Access Compliance Report Public Rights-of-Way (Curb Ramps)

Main Street: CHIQUITA_CANYON_DR Cross Street: COW_CAMP_RD Location: NE

ADA ID: RPRK211124122212 Ramp Type: Type 1 - Perpendicular Diagonal Initial Pass/Fail: Fail Overall Compliance: No Severity Score: 16

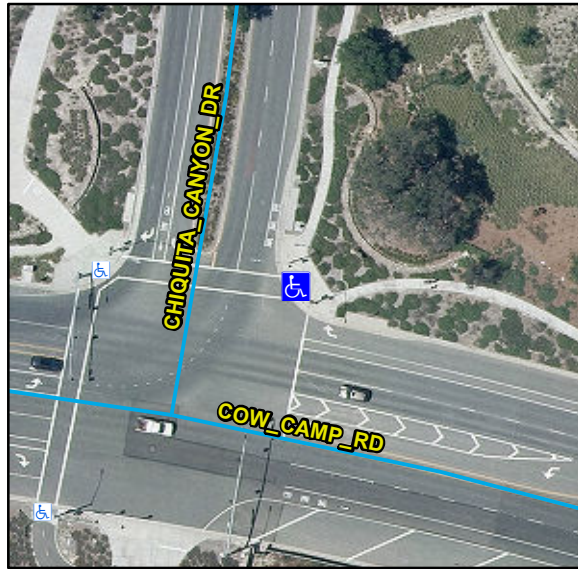
Compliance	Description	Data	Compliance	Description	Data
N/A	Ramp Length (in)	136	N/A	Flare Type LT	
Yes	Ramp Width (in)	48			N/A
No	Ramp Run Slope (%)	8.8	N/A	Flare Slope LT (%)	N/A
Yes	Ramp Cross Slope (%)	1.4	N/A	Flare Traversable LT	N/A
N/A	Landing Present	N/A	N/A	Flare Type RT	
N/A	Landing Length (in)	N/A			N/A
N/A	Landing Width (in)	N/A	N/A	Flare Slope RT (%)	N/A
N/A	Landing Run Slope (%)	N/A	N/A	Flare Traversable RT	N/A
N/A	Landing Cross Slope (%)	N/A	N/A	DWS Provided	N/A
N/A	Landing Movement Obstructed?	N/A	N/A	DWS Contrast	N/A
	Landing Movement Type	N/A	N/A	DWS Length (in)	N/A
N/A	Landing Shared	N/A	N/A	DWS Full Width	N/A
N/A	Clear Space	Yes	N/A	DWS Offset Left (in)	N/A
N/A	Clear Space To Crosswalk (in)	N/A	N/A	DWS Offset Right (in)	N/A
N/A	Marked Crosswalk 1	Yes	N/A	Marked Crosswalk 2	No
	Crossing 1 Direction	W		Crossing 2 Direction	S
	Marked Crosswalk 1 Width (in)	144		Marked Crosswalk 2 Width (in)	N/A

Remove & Replace Curb Ramp With Two New Directional Ramps or Equivalent.

R304.2.2, STD 1115
